Blowing Rock Planning Board

STAFF REPORT

Project: SUP 2025-01 Hampton Inn Hotel
Meeting Date: September 18, 2024
Applicant: Trip Hospitality USA, LLC
Staff: Kevin Rothrock, Planning Director

**PRELIMINARY
CONDITIONAL PERMIT PLANS
FOR
HAMPTON INN HOTEL - BLOWING ROCK**

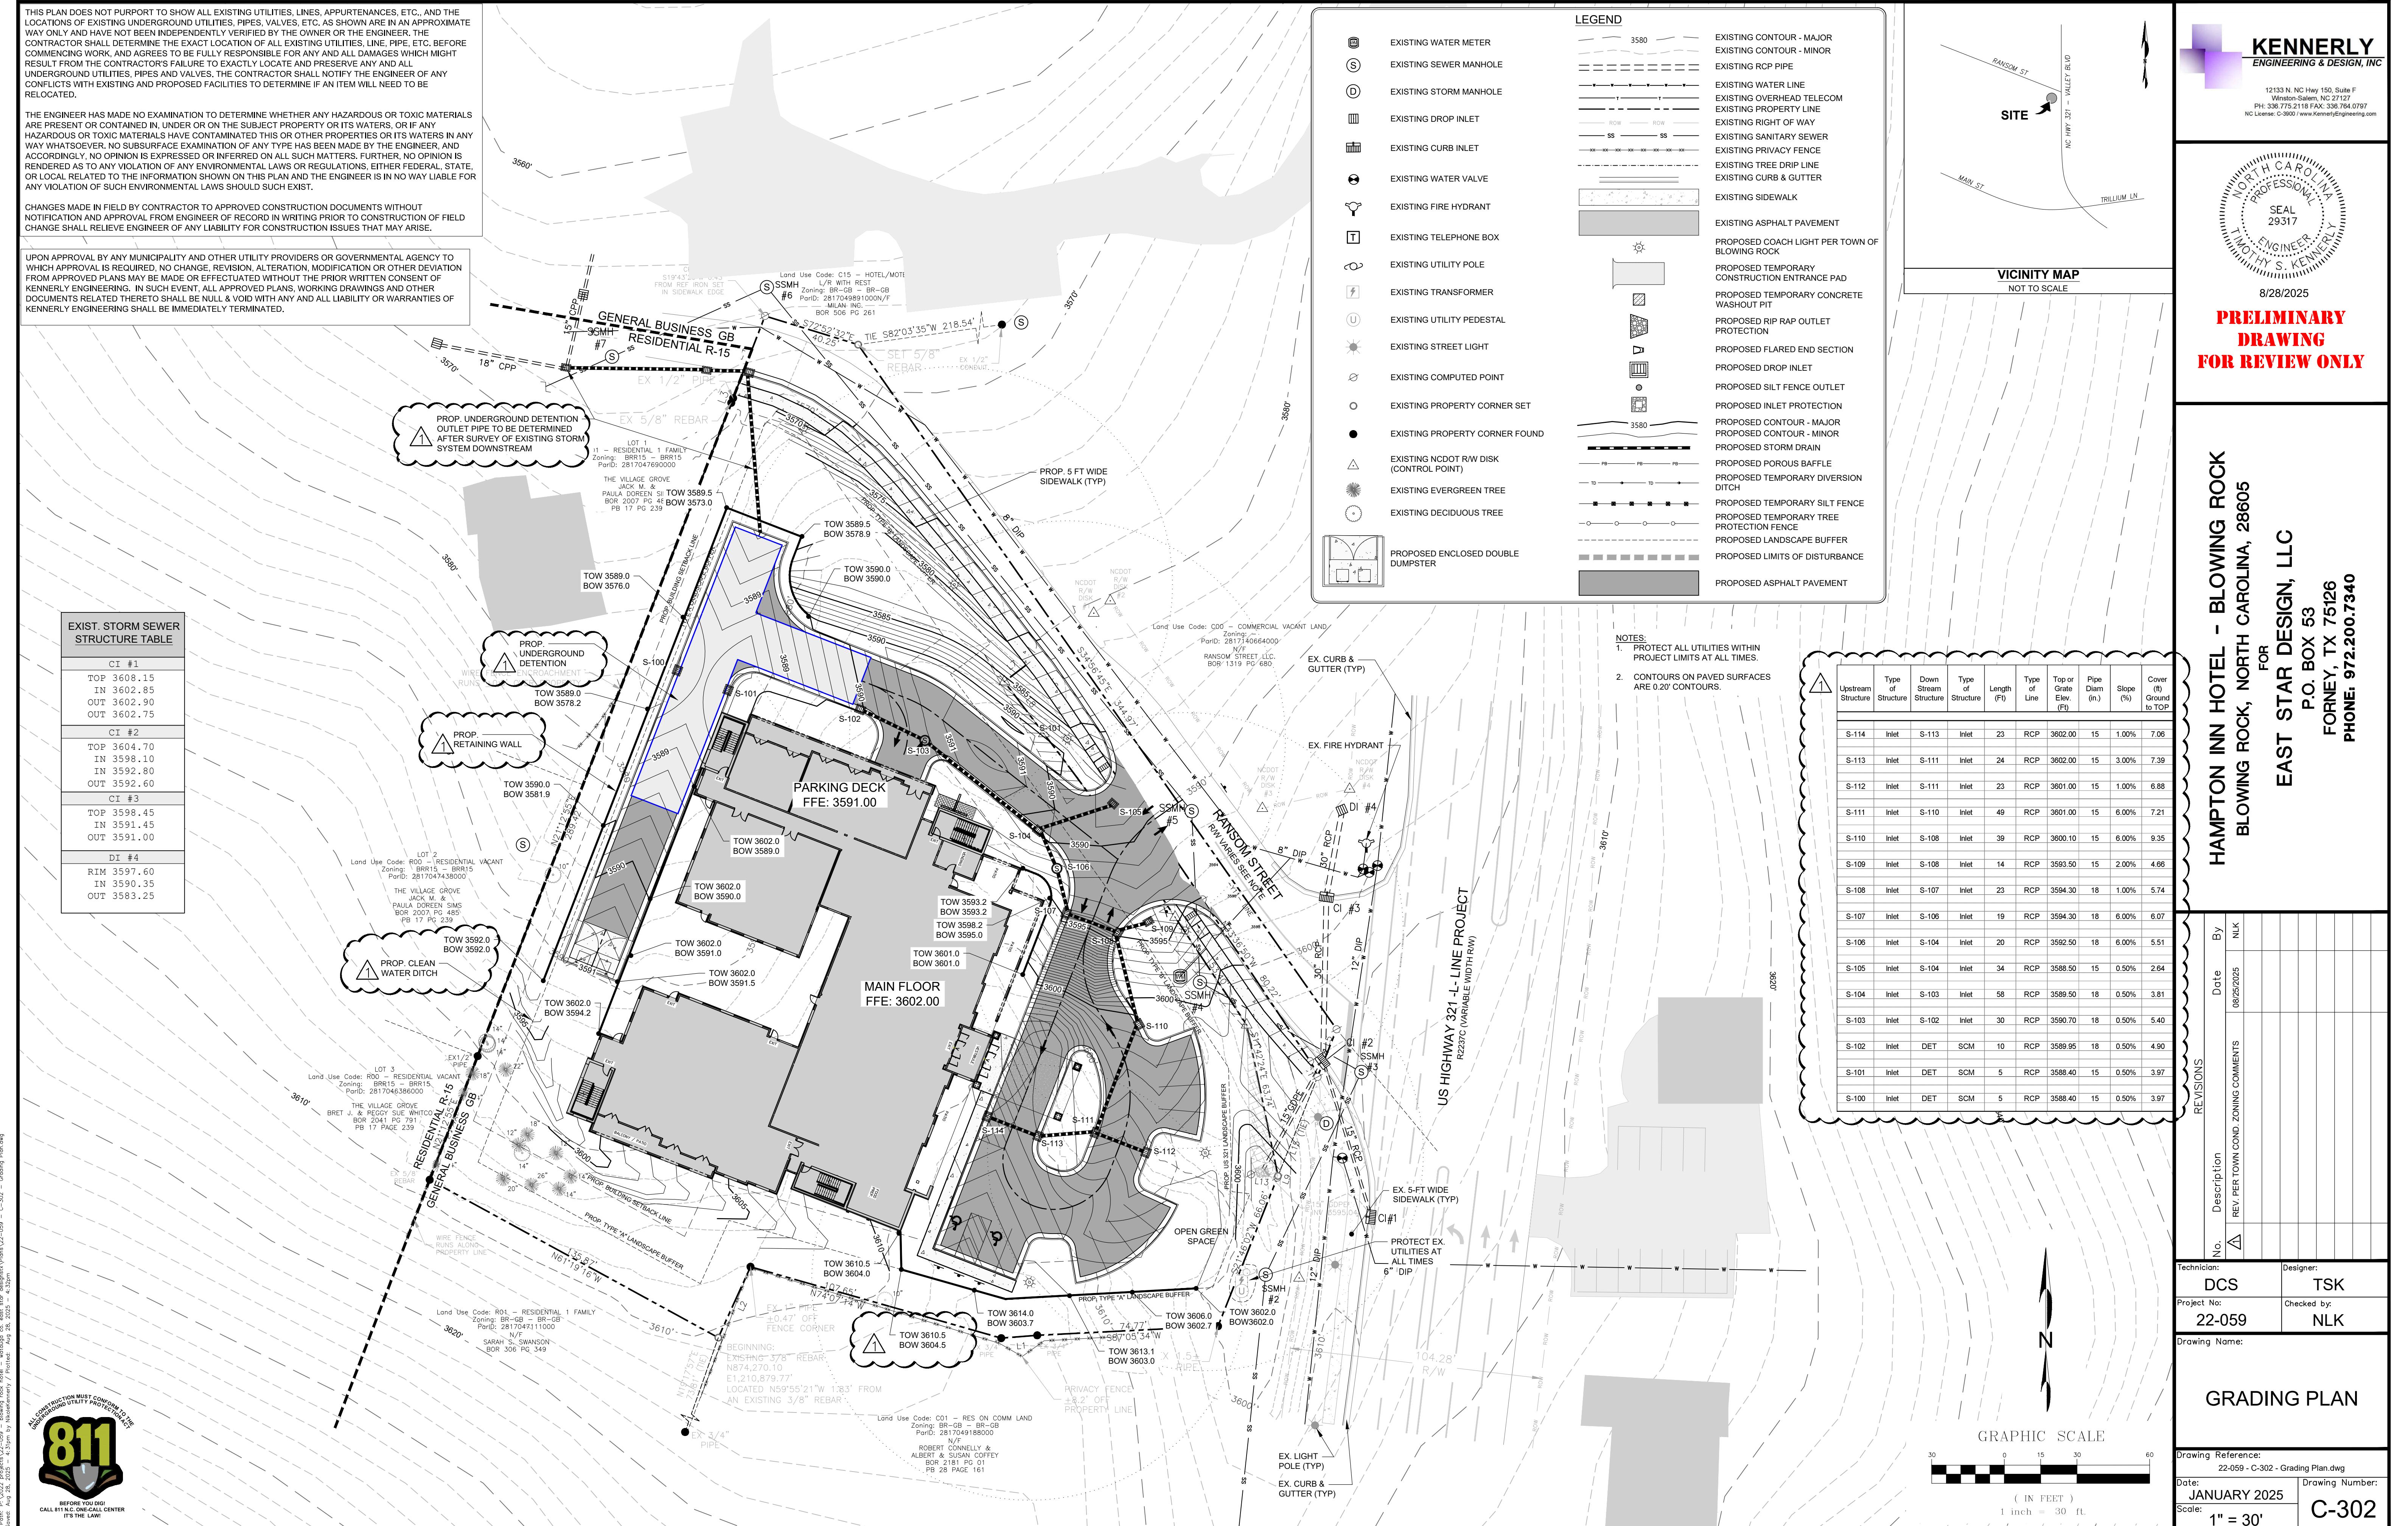
As for the proposed driveway connection to US321, the grading plan currently shows the radius of the proposed driveway connecting to the radius of Ransom Street. It may be possible to consider a RIRO connection to US321 if we could get a minimum of 100ft tangent length from driveway end of radius to Ransom St end of radius. It's our policy to maintain a separation between access points a desired minimum distance of 100ft. Also, with the development as proposed, I would be concerned about traffic potentially traveling against the flow of traffic to turn left through the median break creating an unsafe movement. The apparent safest connection to the highway system would be via Ransom Street. If reference to the NCDOT's Policy on Street and Driveway Access to NC Highways is needed, then I would start by referencing page 26 where it states "*The NCDOT may prohibit or restrict access to a State Highway System roadway if alternate access is available through other adjacent public facilities.*" Since access to the highway system can be adequately gained using Ransom St, we would not allow direct access to US321 as proposed.

CODE PLANTING PLAN
Drawing Reference: 22-059 - C-600 - Code Planting Plan.dwg
Date: JANUARY 2025 Drawing Number: C-600
Scale: 1" = 30' (IN FEET)

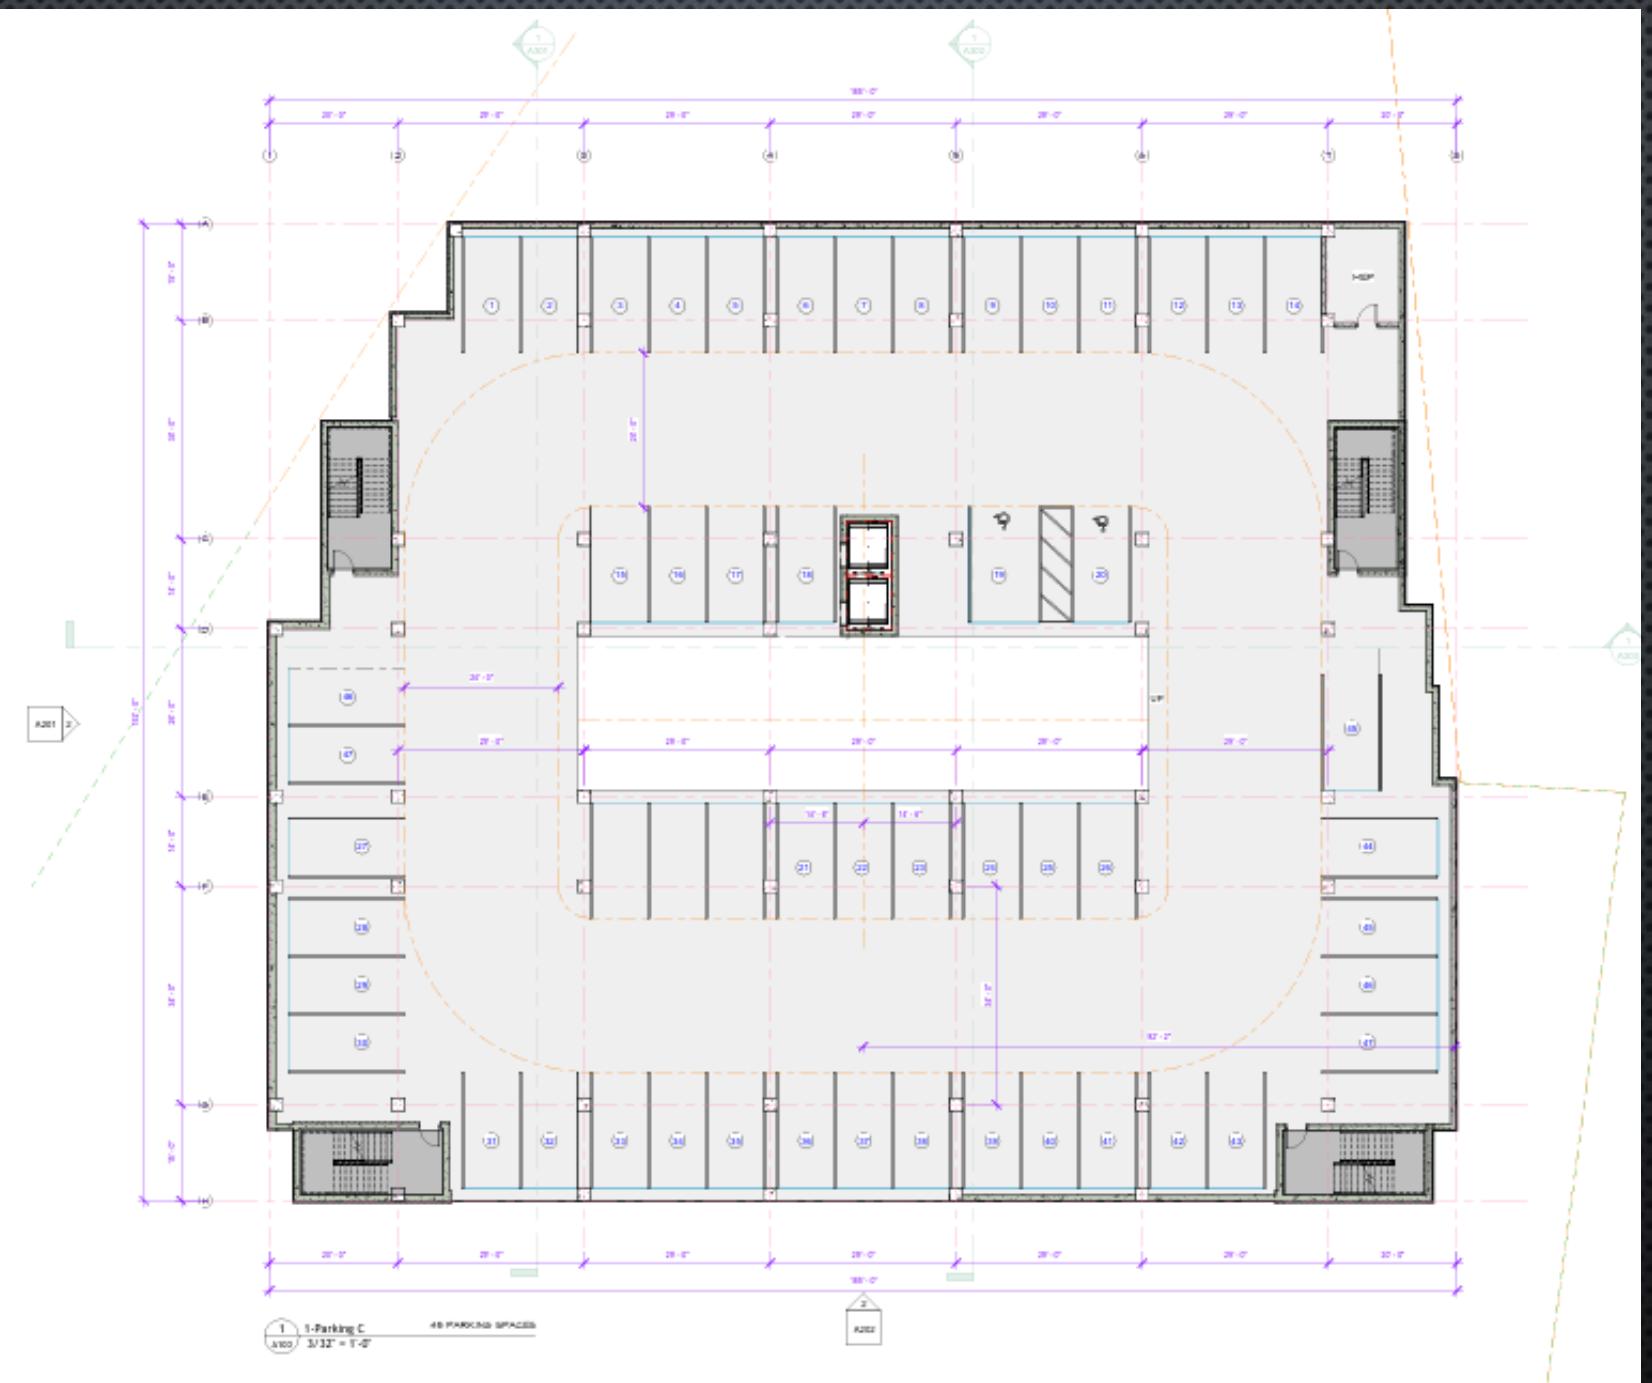
In areas of the site where the buffering should be the most effective, staff recommends staggering the planting of evergreen trees or shrubs in two rows to provide buffer depth. This would be along the southern and western property lines where the proposed hotel abuts residential uses.
